Access Compliance Report

Public Rights-of-Way

(Curb Ramps)

Intersection ID: 11847	Main Street: N_TRYON_ST	Cross Street: W_9TH_ST	Location:	N
ADA ID: 858E28A36D23	Ramp Type: PerpDiag	Initial Pass/Fail: Fail	Overall Compliance: No	Severity Score: 10

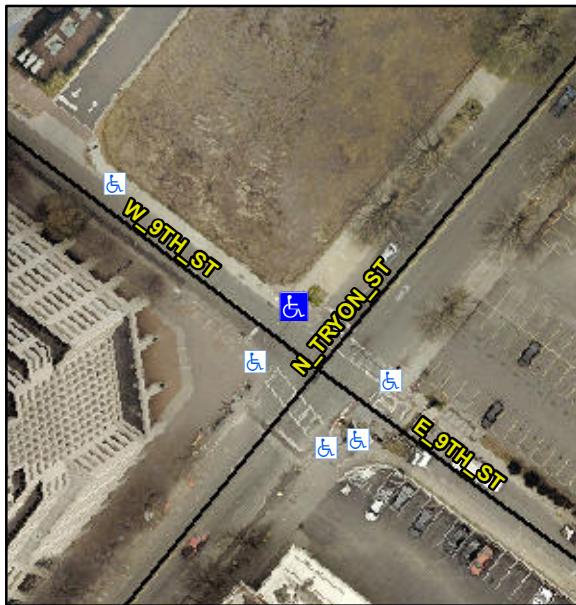
Not Found, R304.5.1, R304.5.3

Compliance	Description	Data	Compliance	Description	Data
N/A	Ramp Length (in)	61.0	Yes	Ramp Slope (%)	6.0
No	Ramp Width (in)	41.5	No	Ramp XSlope (%)	3.2
N/A	Flare Type LT	N/A	N/A	Flare Type RT	N/A
N/A	Flare Slope LT (%)	N/A	N/A	Flare Slope RT (%)	N/A
N/A	Flare Traversable LT?	N/A	N/A	Flare Traversable RT?	N/A
N/A	Landing Length (in)	N/A	N/A	DWS Provided?	N/A
N/A	Landing Width (in)	N/A	N/A	DWS Contrast?	N/A
N/A	Landing Slope (%)	N/A	N/A	DWS Length (in)	N/A
N/A	Landing X Slope (%)	N/A	N/A	DWS Full Width?	N/A
N/A	Landing Curb? (Y/N)	N/A	N/A	DWS Offset (in)	N/A
N/A	Shared Landing?	N/A			
N/A	Gutter Ponding?	N/A	N/A	Gutter Slope (%)	N/A
N/A	Gutter Lip Ht (in)	N/A	N/A	Gutter X Slope (%)	N/A
N/A	Painted X Walk1?	Yes	N/A	Painted X Walk2?	Yes
	X Walk 1 Direction	To SW		X Walk 2 Direction	To SE
N/A	X Walk 1 Width (in)	112.0	N/A	X Walk 2 Width (in)	104.0
	X Walk 1 Slope (%)	1.2		X Walk 2 Slope (%)	1.6
	X Walk 1 X Slope (%)	1.7		X Walk 2 X Slope (%)	1.3

Remove & Replace Curb Ramp With Two New Directional Ramps or Equivalent.
